Attorney Docket No. 10559-350001  
Application No. 09/662,054  
Amendment dated December 4, 2003  
Reply to office action dated October 6, 2003

Amendments to the Drawings:

The attached replacement sheet 1 of drawings includes changes to Fig. 1 and replaces the original sheet including Fig. 1.

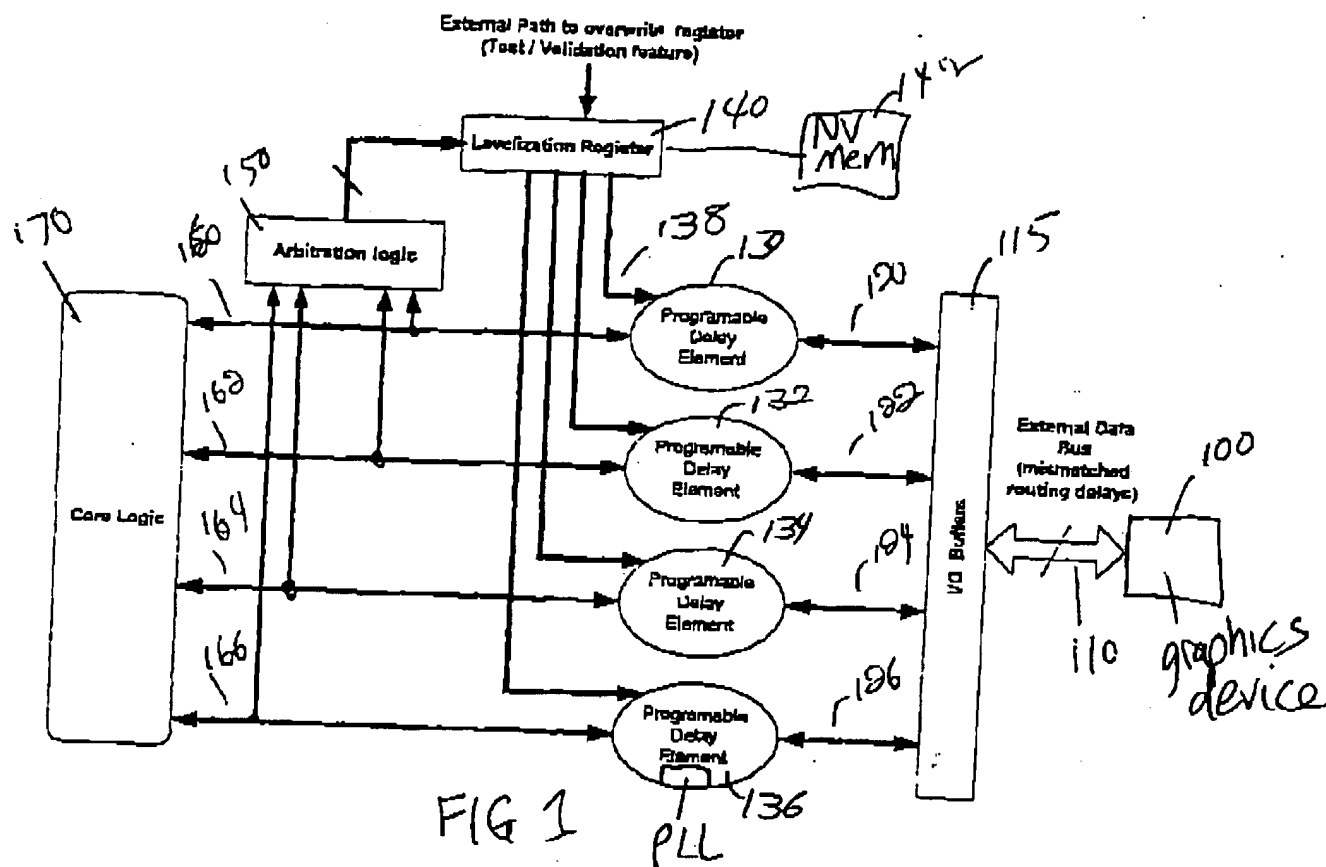
Figure 1 has been amended to show that the delay elements may be a phase locked loop, and also to show the graphics element.
